Serial No.: 10/089,072
Atty. Docket No.: P67777US0

REMARKS

The Final Office Action mailed December 23 2003, has been carefully reviewed and by this Amendment, claims 8-10 and 12-19 have been amended. Accordingly, claims 8-27 remain pending in the application. In view of the foregoing amendments and the following remarks, favorable consideration and allowance of this application is respectfully requested.

Fig 1.

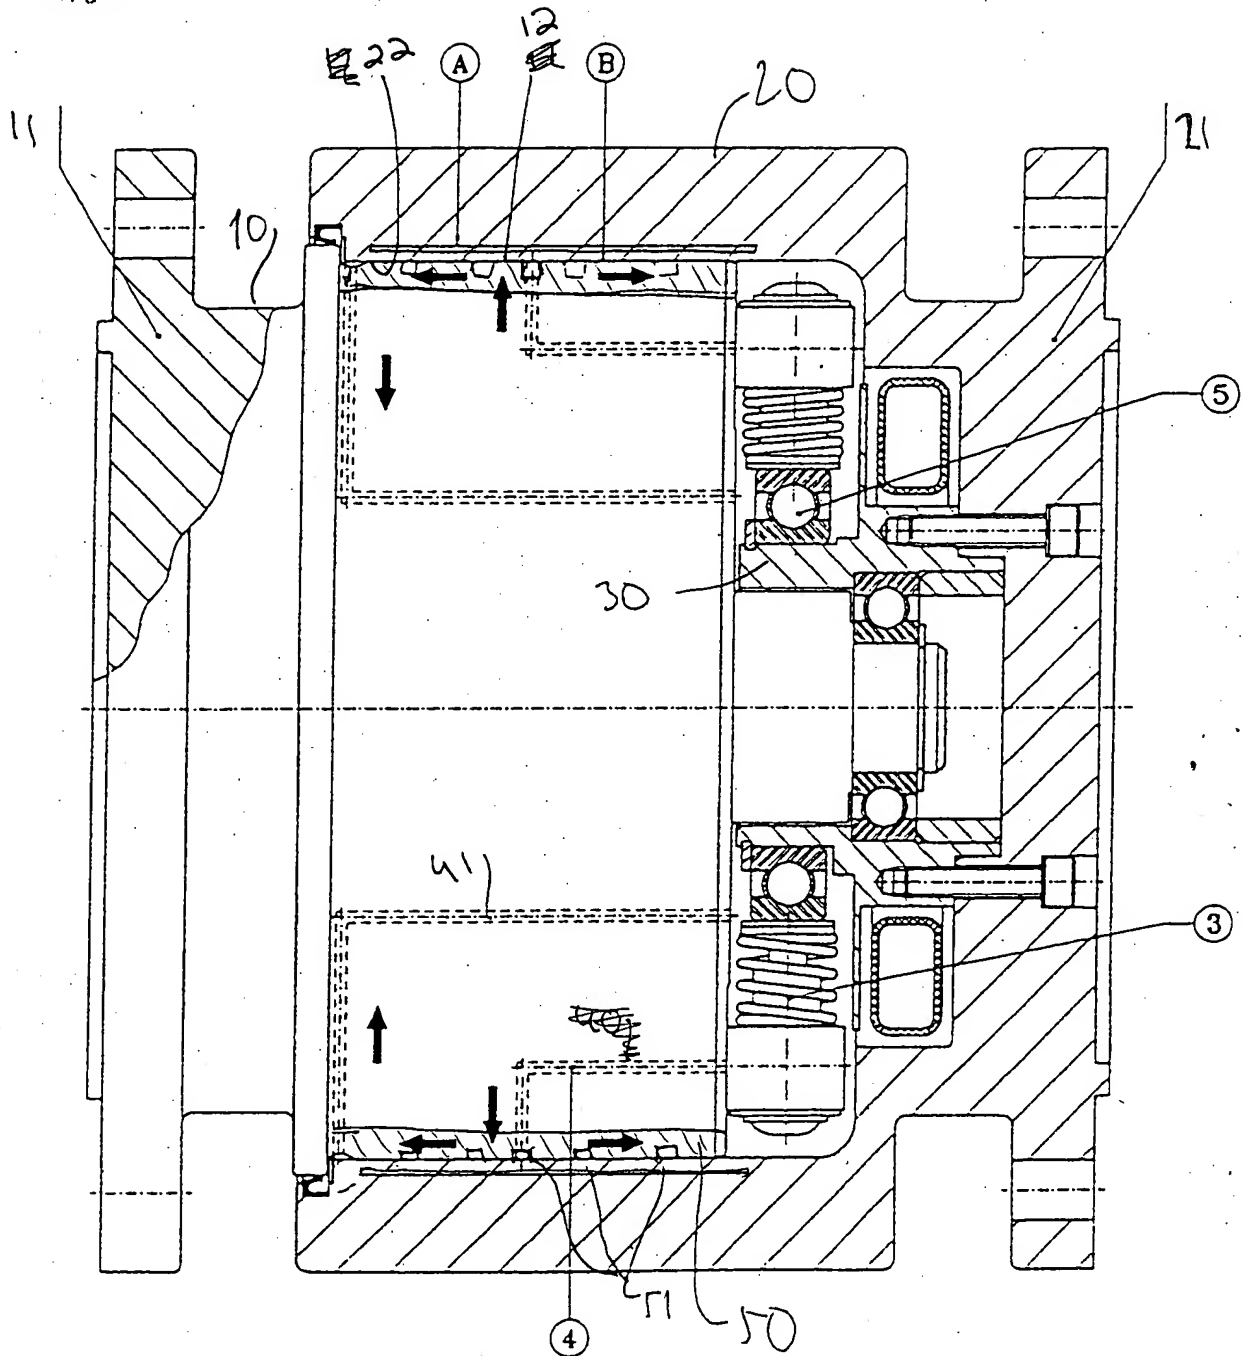
The Examiner objected to the drawings as containing various informalities which Applicant has corrected herein. These changes include clarification of the surfaces intended to be designated by reference numerals "12" and "22", namely that "12" (not 10) designates the outer surface of the shaft 10, while "22" designates the inner surface of the sleeve 20, as indicated in red on the attached drawing. Favorable consideration and entry of such changes are requested.
